FACTORY DIRECTED MODIFICATION

The following units must be modified:
KX250-A6: before frame number KX250-501493
KX420-A1 before frame number KX420-500825

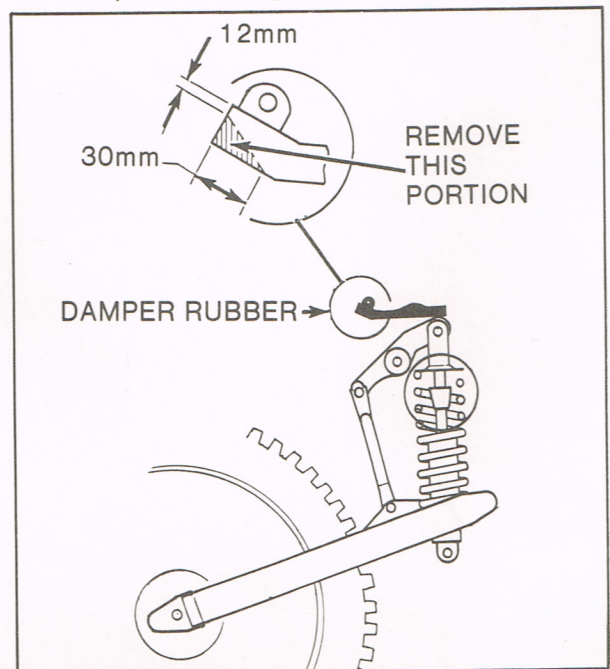
1. Remove the seat and both plastic side covers (number plates).
2. Remove the damper rubber. Cut or grind the end of the rubber as shown.

NOTE: To remove the damper, compress the suspension slightly.

3. Reinstall the damper.

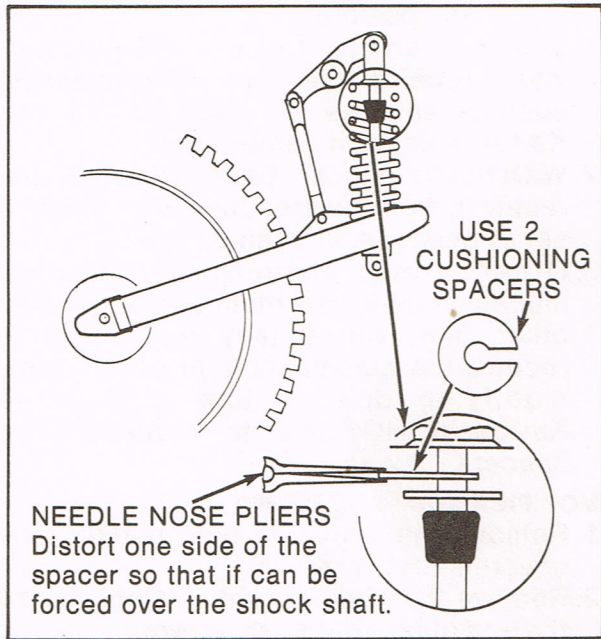
4. Pull down the shock absorber rubber bumper. Use needlenose pliers to insert two (2) of the flexible cushion spacers supplied by Kawasaki.

NOTE: There are two spacer sizes. One has a 16.5 mm hole for the KX250 shock absorber shaft. The other has a 20.5 mm hole for the KX420.
